Nuclear Operating Company

November 29, 2010
U7-C-STP-NRC-100253

South Texas Project
Units 3 and 4
Docket Nos. 52-012 and 52-013
Revised Response to Request for Additional Information

1. RAI 03.04.02-6, Revision 2
2. RAI 03.04.02-11, Revision 1
3. RAI 03.07.01-25, Supplement 1
4. RAI 03.07.02-24, Supplement 1
5. RAI 03.08.01-4, Revision 2
6. RAI 03.08.01-7, Revision 2
7. RAI 03.08.01-9, Revision 1
8. RAI 03.08.01-10, Revision 1

Figure 3H.6-216: Lateral Seismic Soil Pressures (psf) on RSW Piping Tunnel East Wall (Main Cross Section of RSW Piping Tunnel, Including Effect of Vertical Excitation)

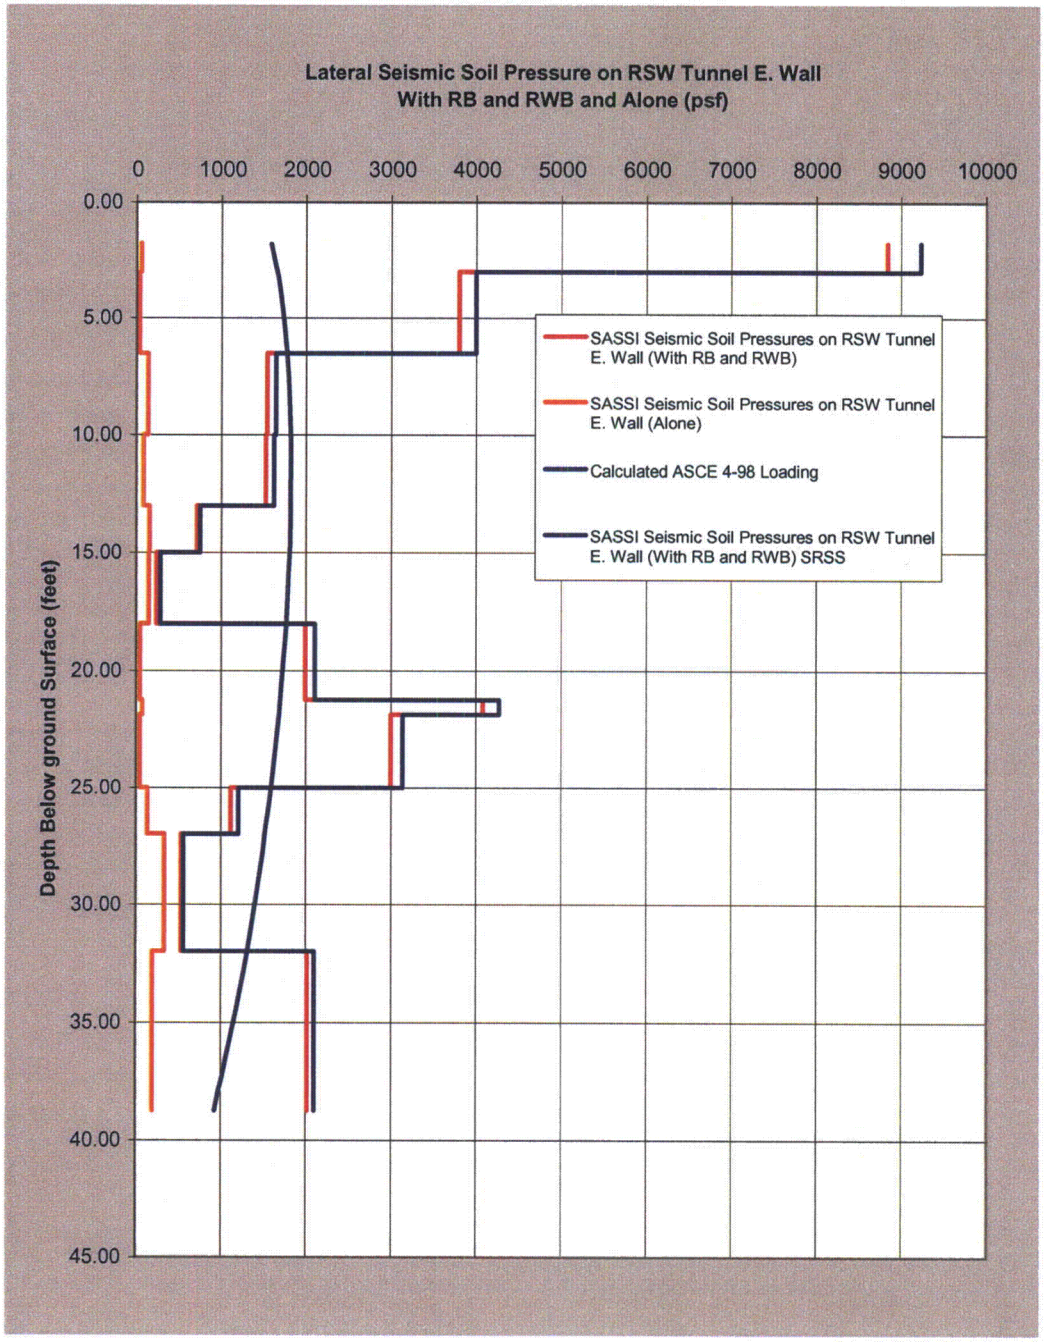
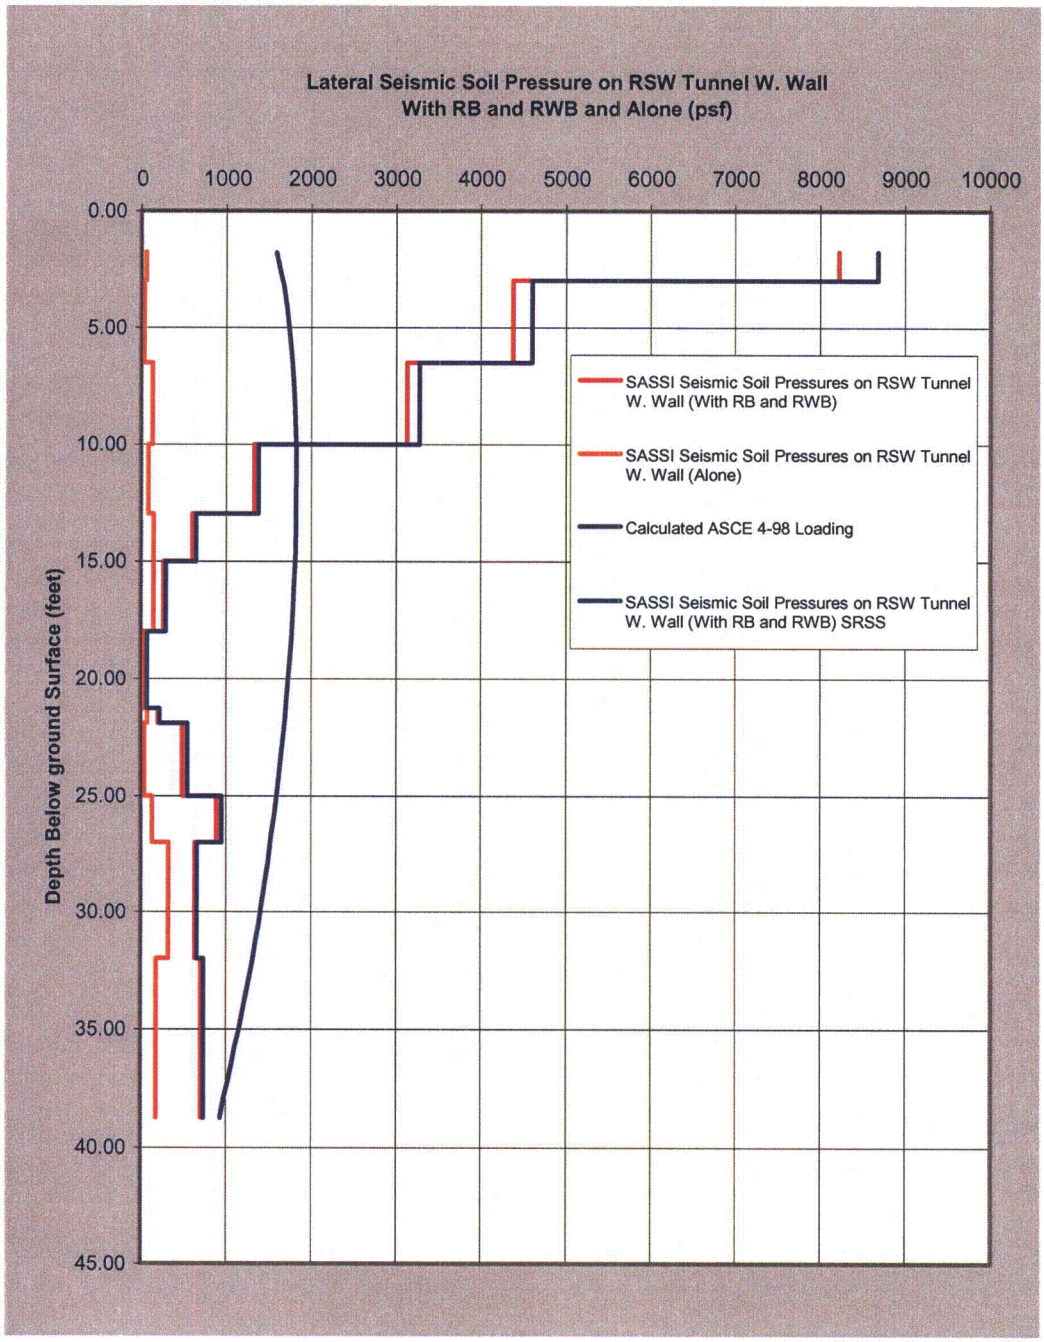
a) Staff has not endorsed ASCE 4-98 Section C3.3.3.4 as acceptable criteria for selecting the cutoff frequency for the SSI analysis for detailed finite element model such as UHS Basin with cooling tower enclosure and RSW Pump House. The applicant is requested to provide comparisons of in-structure response spectra at some selected locations by increasing the frequency cut-off to a minimum of 33 Hz and using a SSI model capable of transmitting a frequency up to 33 Hz (refer to Follow-up Question to RAI 03.07.02-17) for all analysis cases considered demonstrating that cut-off frequencies used in the SSI analysis are acceptable. The staff needs this information to ensure that the selected cut off frequencies less than 33 Hz in SSI analysis will accurately or conservatively account for the expected frequency content of the SSE in the SSI analysis.

In the above described SSSI analyses, consistent with the SSSI analysis for certified design of the RB and CB, vertical input motion was considered to have negligible effect on the calculated soil pressures. To verify this, the SSSI analysis of the E-W 2D section of the RSW Piping Tunnel between the RWB and RB was analyzed for both the E-W and vertical input motions. The resulting soil pressures, based on SRSS of the results for the two motions, shown in Figures 3H.6-216 and 3H.6-217 show that the effect of vertical input motion is negligible.
